CONSTRUCTION CONTRACT CHANGE ORDER NUMBER: 004

Project: CR 58 Widening From CR 48 to Sav

Slope Paving for SETs in Detention Pond

Document Type: Change Order Memorandum
Subject: Change Order 04
Project: 0912-31-304; CR 58
Description: Slope Paving for Detention Pond SETs

**CR 58
FROM SAVANNAH DEVELOPMENT TO CR 48
DETENTION POND
LAYOUT**

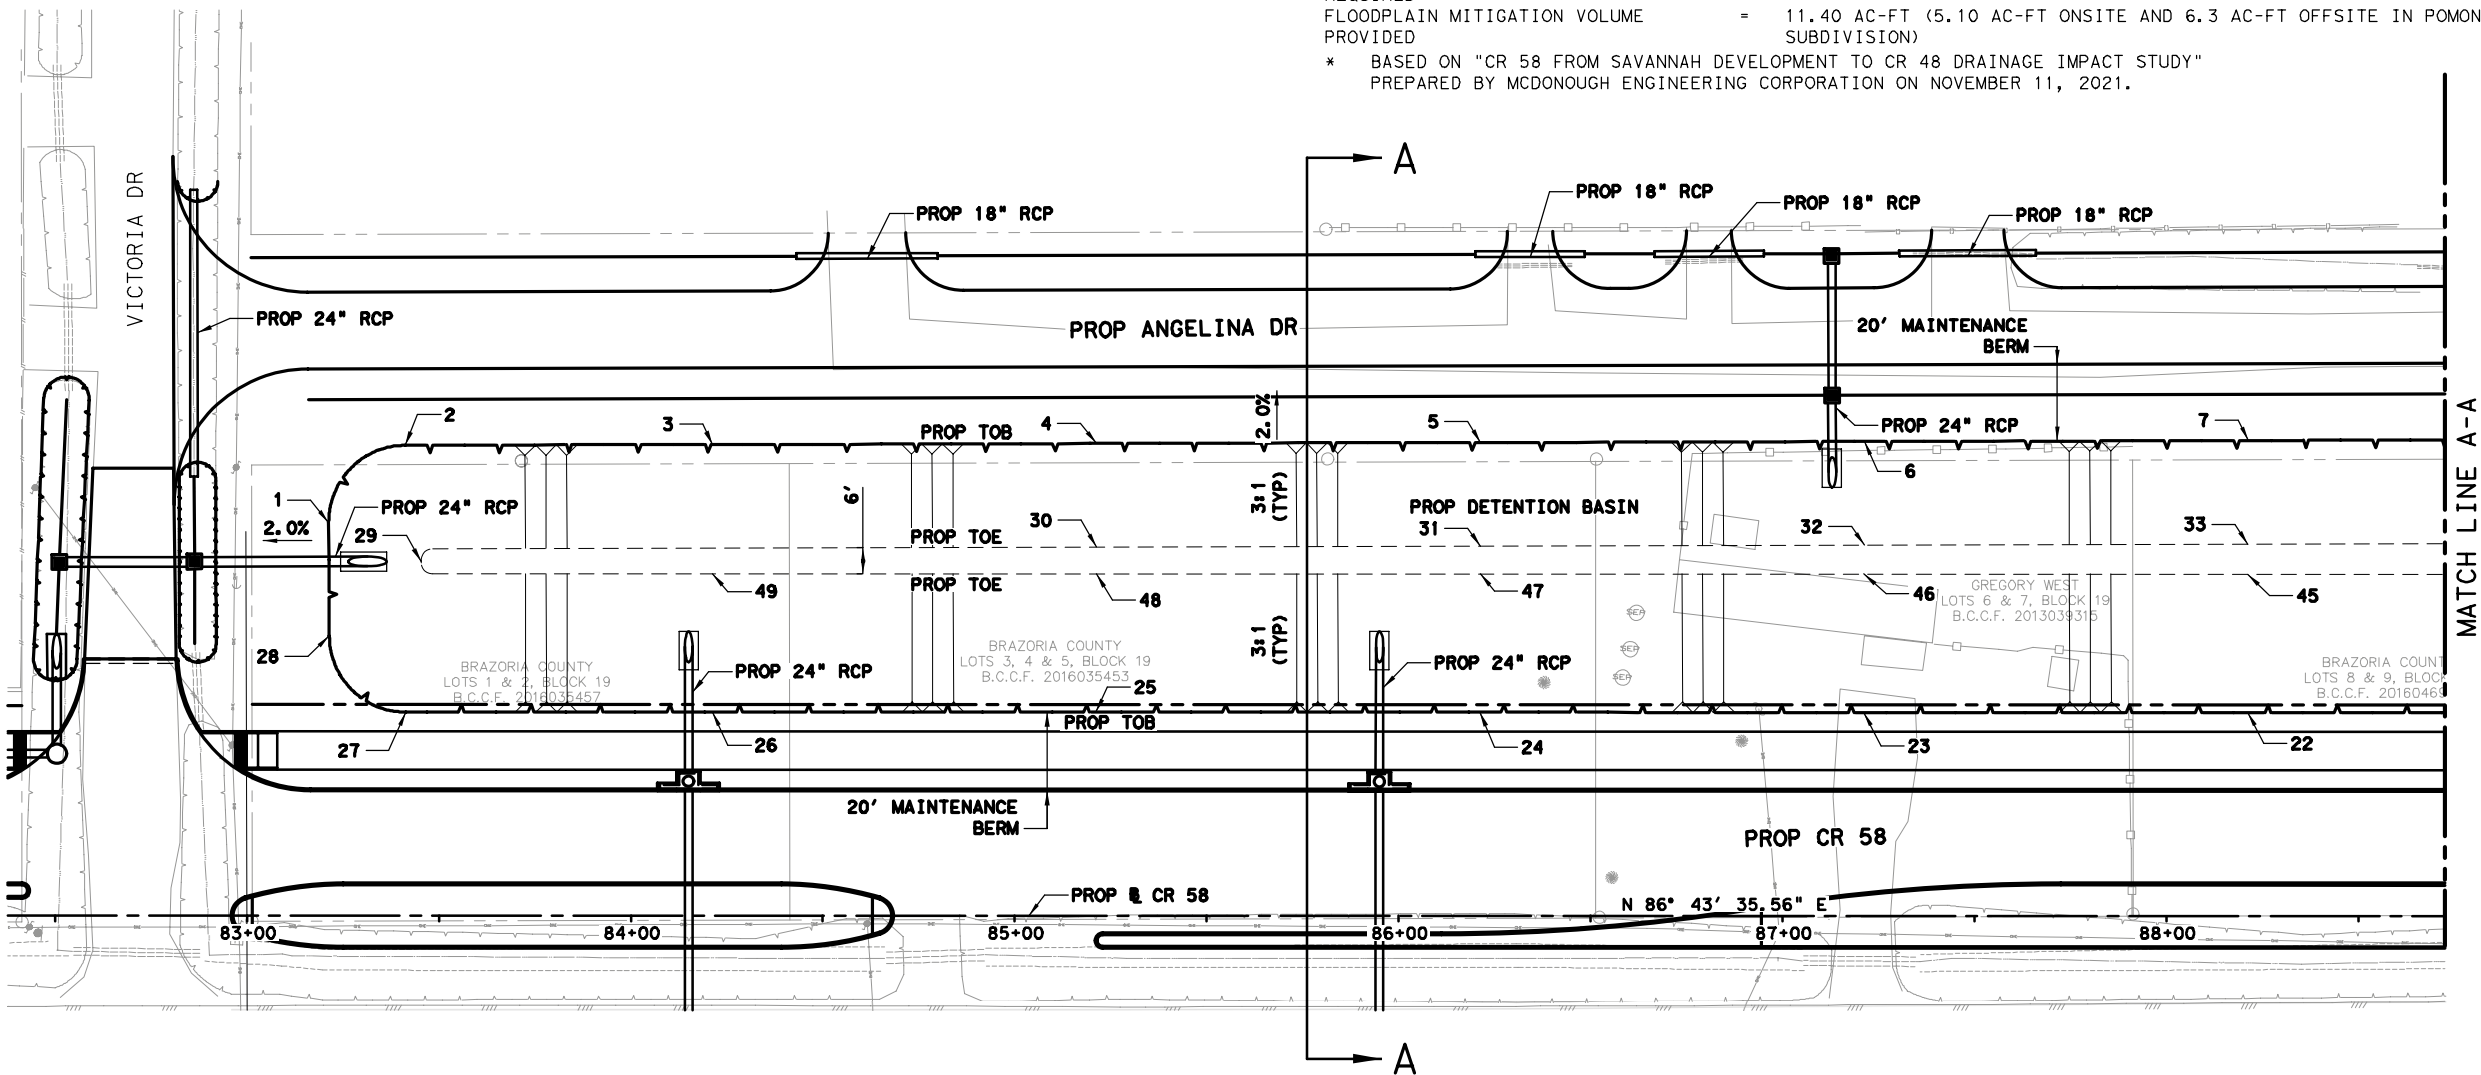
The attached plan sheets 132 – 135 show the SETs that are included with this change order. There are 12 EA – 24" SETs; 1 EA – 30" SET; and 3 EA – 6' x 3' SETs. Using the BDD4 details, the estimated work quantities are:

- 24" SET – 30 LF toe wall, 53 SF slope paving
- 30" SET – 35 LF toe wall, 62 SF slope Paving
- 6' x 3' SET – 50 LF toe wall, 92 SF slope paving

TYPICAL SLOPE PAVING FOR SAFETY END TREATMENT (S.E.T.)

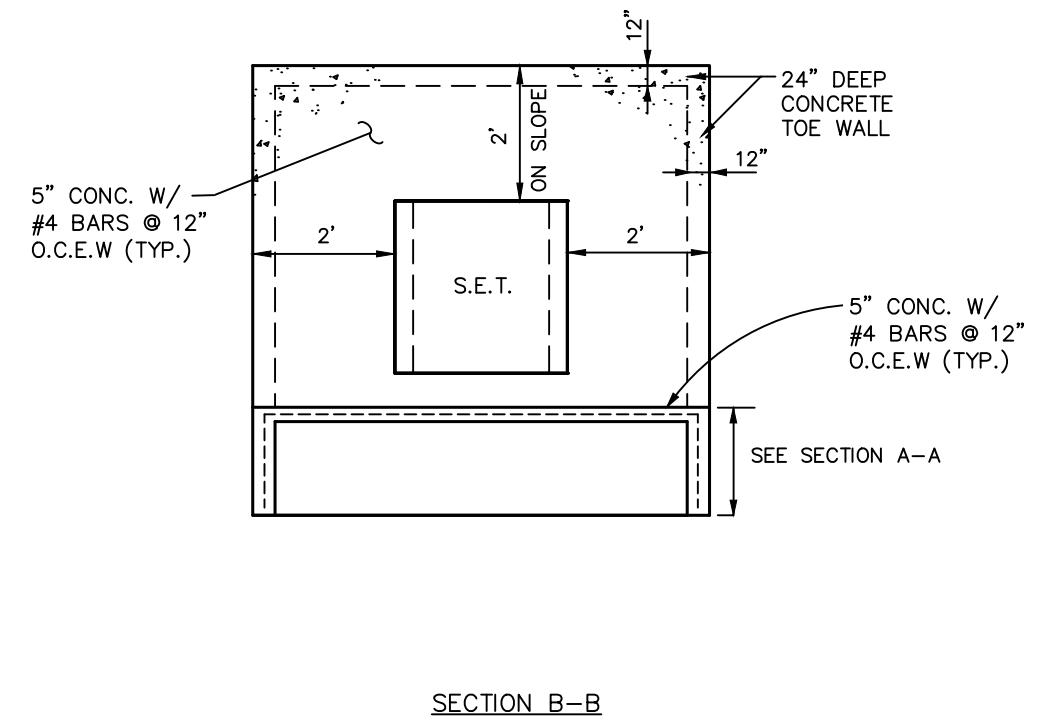
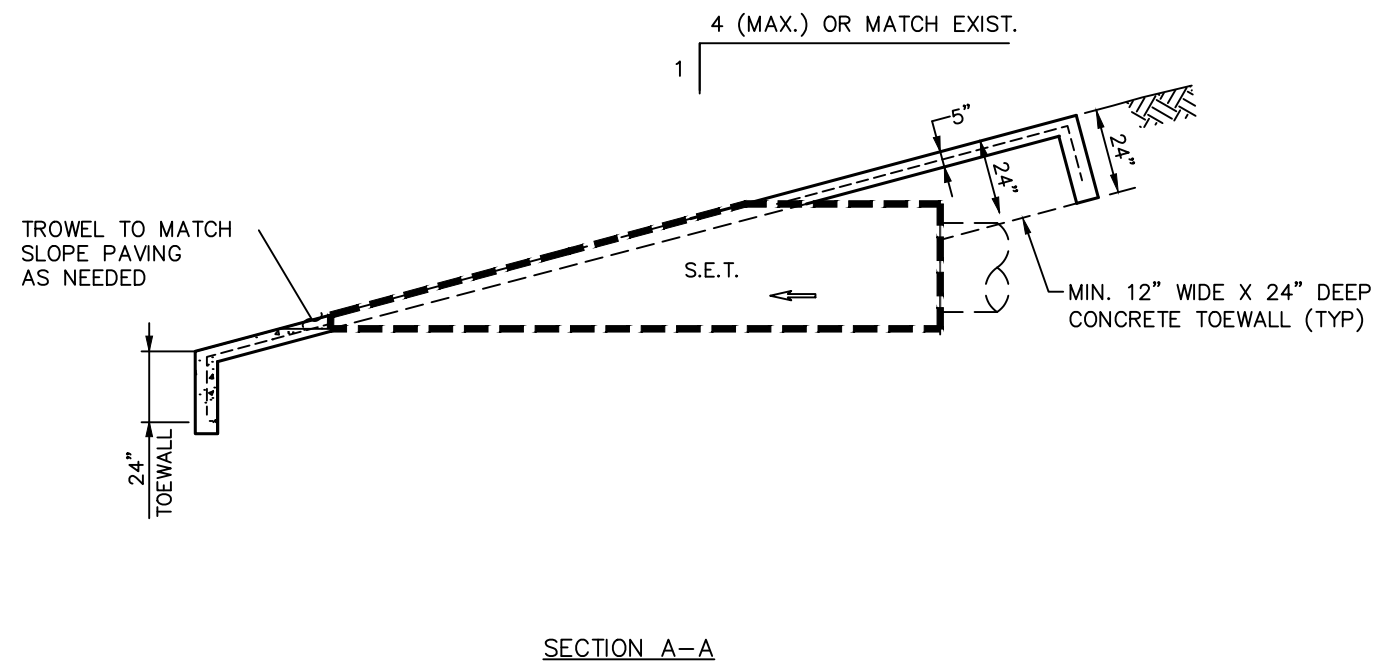
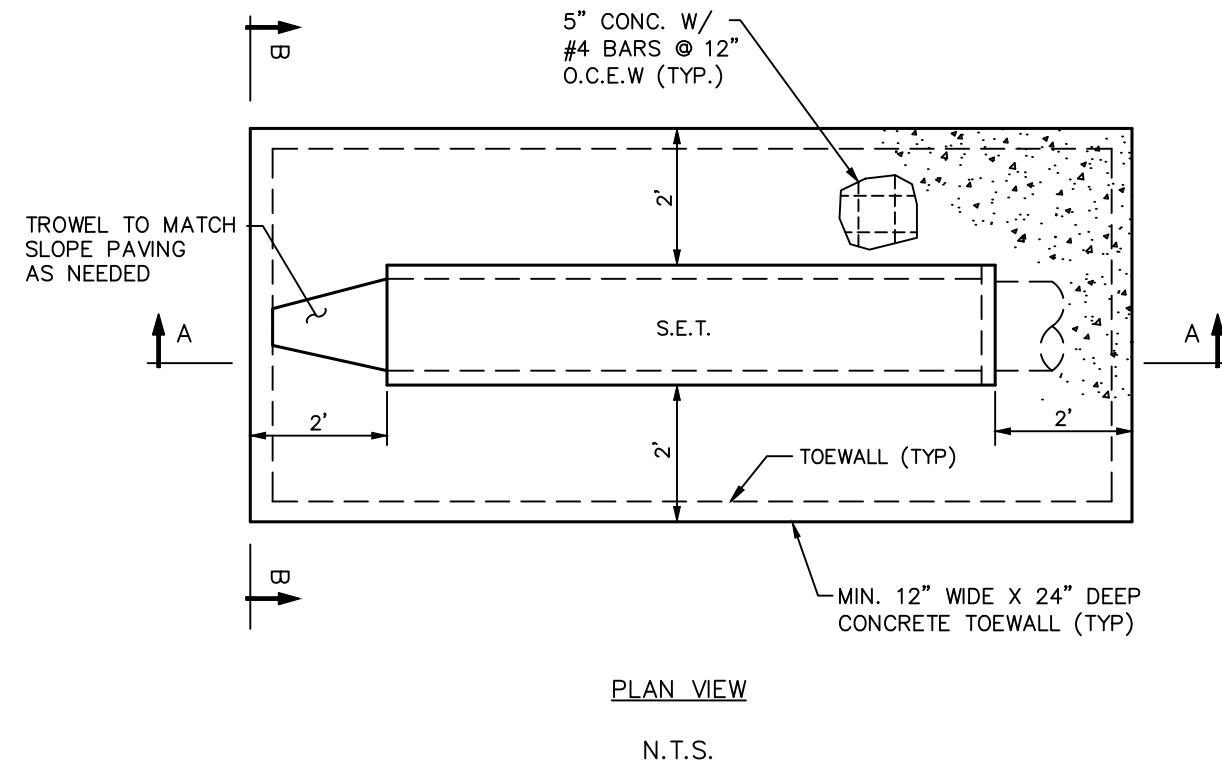
This change order includes the BDD4 slope paving details as added plan sheet 145A.

On the Typical Slope Paving drawing:

Question as to the 3K called out, as this is a structural support does it not needs to be 3.6K or 4K?

The design needs calculations included.

Question as to the 5" concrete with #4 Bars at 12" OCEW, should these not be at 8" with the 2' width?

Please provide what information is available on the calculations for the design.

1. THE DIMENSIONS SHOWN ARE THE MINIMUM REQUIRED BY THE DISTRICT.
2. THE PAVING THICKNESS AND REBAR PLACEMENT SHALL MEET THE MINIMUM REQUIREMENTS SHOWN IN THIS DETAIL
3. ALL CONCRETE MUST HAVE A MINIMUM COMPRESSIVE STRENGTH OF 3,000 PSI AT 28 DAYS.
4. MINIMUM YIELD STRENGTH OF REBAR SHALL BE #4 BARS, 60,000 PSI (GRADE 60) AND PLACED AT 12" C/C EACH WAY.
